### **TURKEY POINT NUCLEAR GENERATING STATION UNIT 3 AND UNIT 4**

#### **IMPROVED TECHNICAL SPECIFICATIONS CONVERSION**

##### **ITS SECTION 3.1 REACTIVITY CONTROL SYSTEMS**

**Revision 0**

Figure 3.1.3 - 1 (page 1 of 1)  
Moderator Temperature Coefficient Vs. Rated Thermal Power

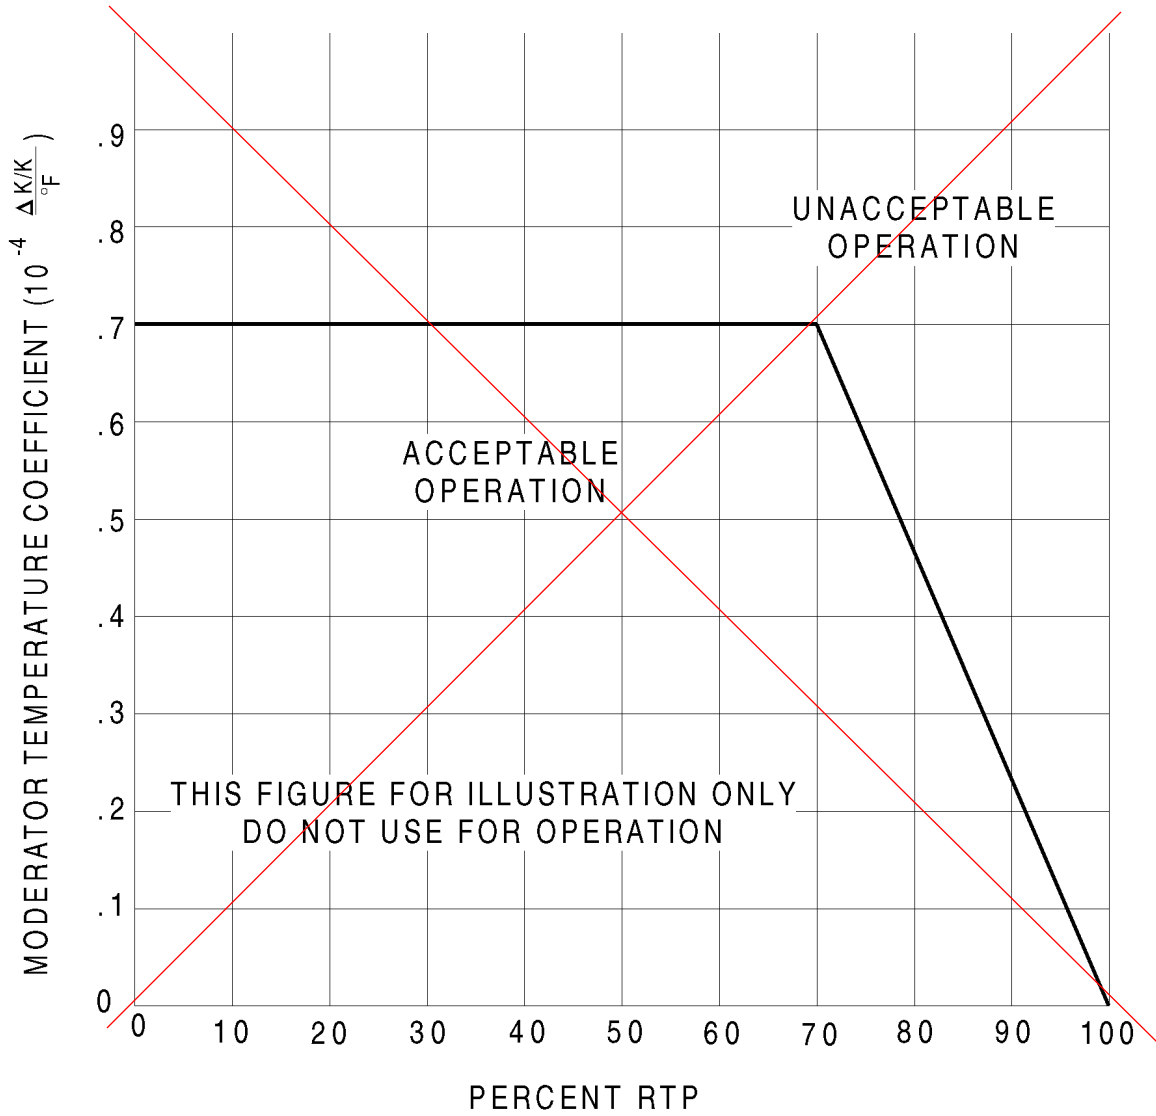
3.1.1.3 LCO 3.1.3 The MTC shall be maintained within the limits specified in the COLR. The maximum upper limit shall be  $\leq [-]$   $\Delta k/k^\circ F$  ~~at hot zero power~~ [that specified in Figure 3.1.3-1].

Figure B 3.1.6 (page 1 of 1)  
Control Bank Insertion vs. Percent RTP

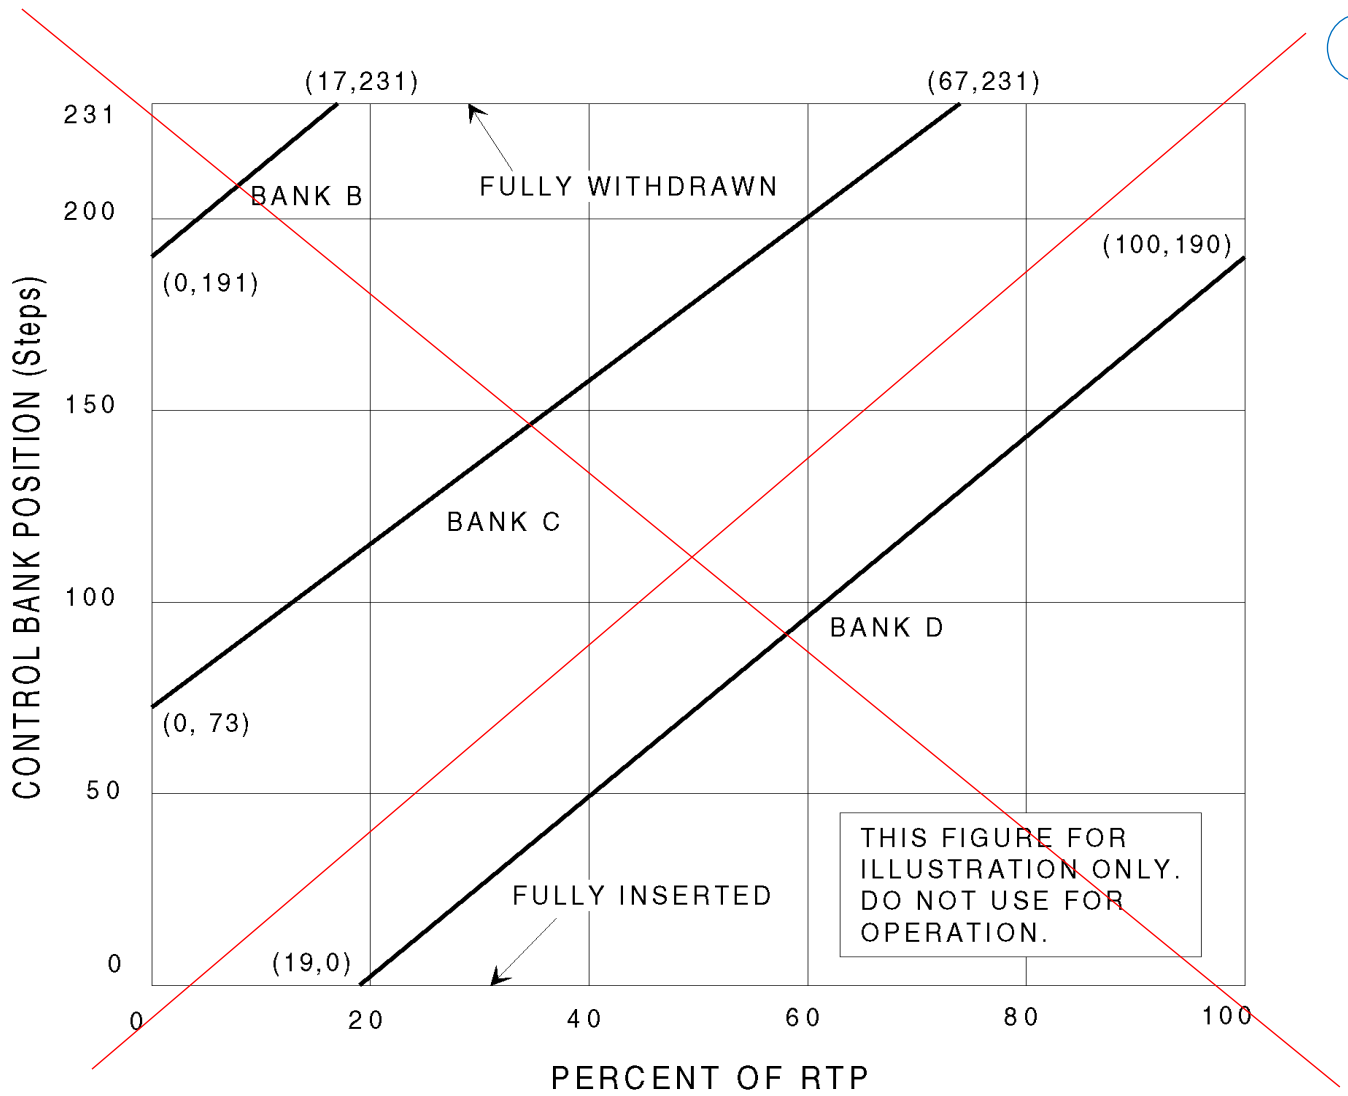
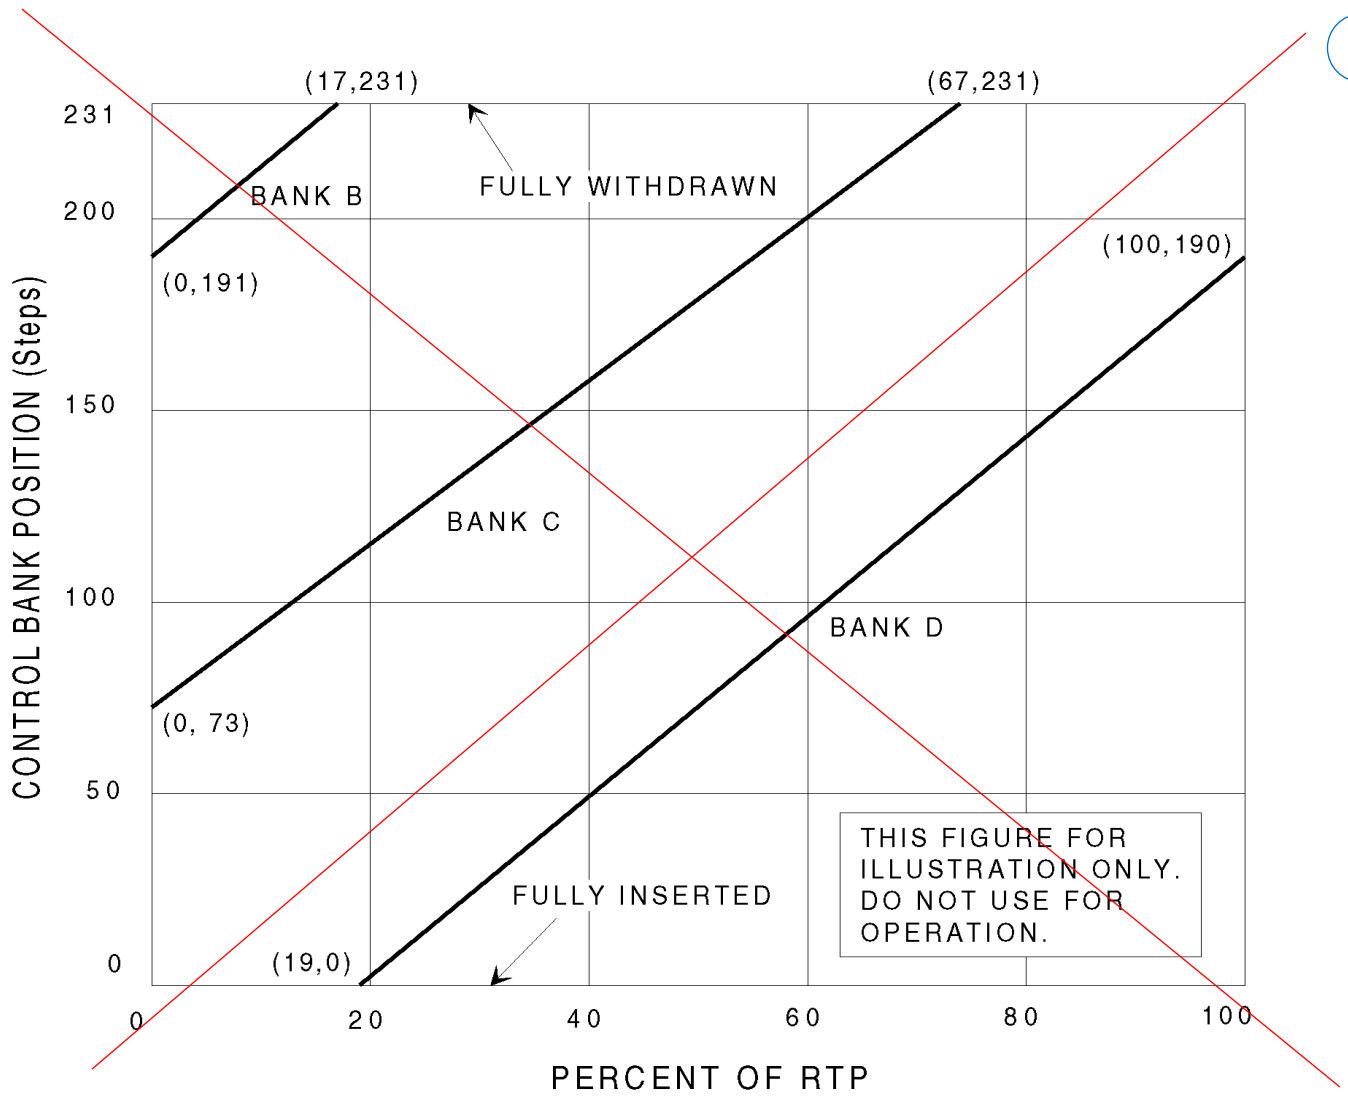
2. ISTS 3.1.6 contains Figure B 3.1.6-1 and states that it is an example provided for information only. Turkey Point Nuclear Generating Station (PTN) Improved Technical Specification (ITS) 3.1.6 does not include Figure B 3.1.6-1. The control bank insertion limits for PTN are located in the Core Operating Limits Report (COLR). Therefore, ISTS Figure B 3.1.6-1 and the references to the ISTS Figure B 3.1.6-1 have been deleted.

Figure 3.1-2  
BORIC ACID TANK MINIMUM VOLUME (1)  
Modes 1, 2, 3 and 4

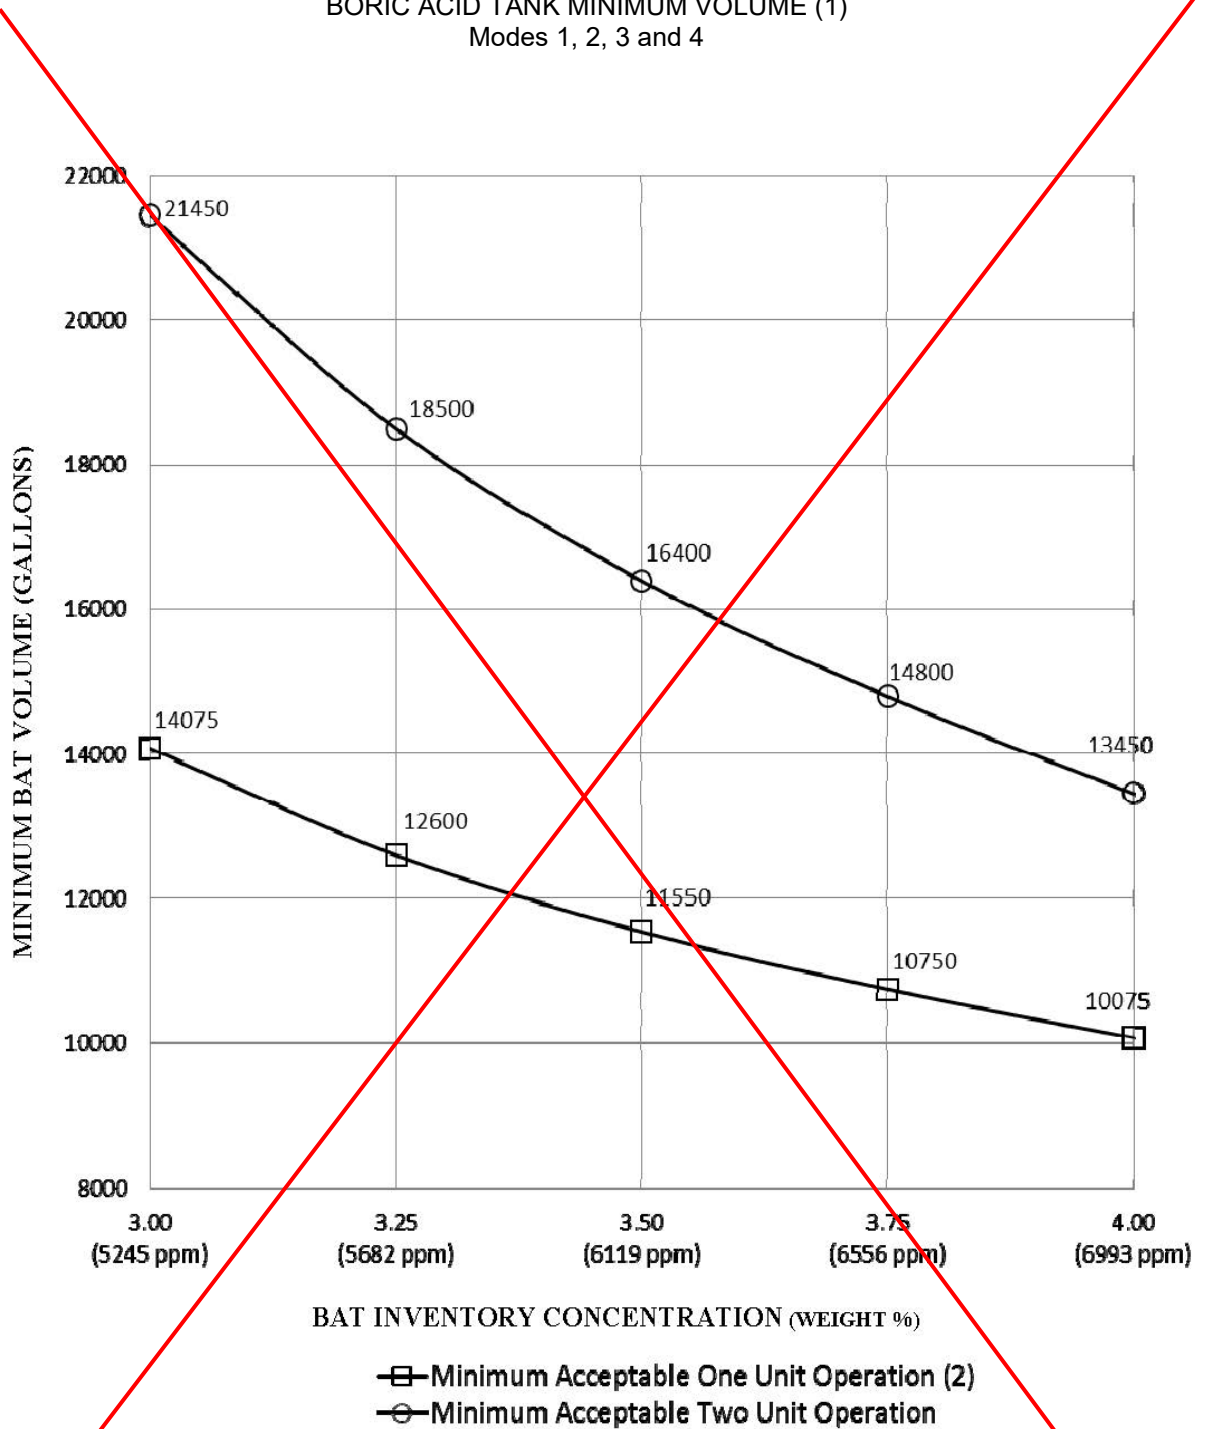
- a. ~~— A Boric Acid Storage System with:~~
  - 1) ~~— A minimum indicated borated water volume in accordance with Figure 3.1-2,~~
  - 2) ~~— A boron concentration in accordance with Figure 3.1-2, and~~
  - 3) ~~— A minimum boric acid tanks room temperature of 62°F.~~
- b. ~~— The refueling water storage tank (RWST) with:~~
  - 1) ~~— A minimum indicated borated water volume of 320,000 gallons,~~
  - 2) ~~— A boron concentration between 2400 ppm and 2600 ppm.~~
  - 3) ~~— A minimum solution temperature of 39°F, and~~
  - 4) ~~— A maximum solution temperature of 100°F.~~
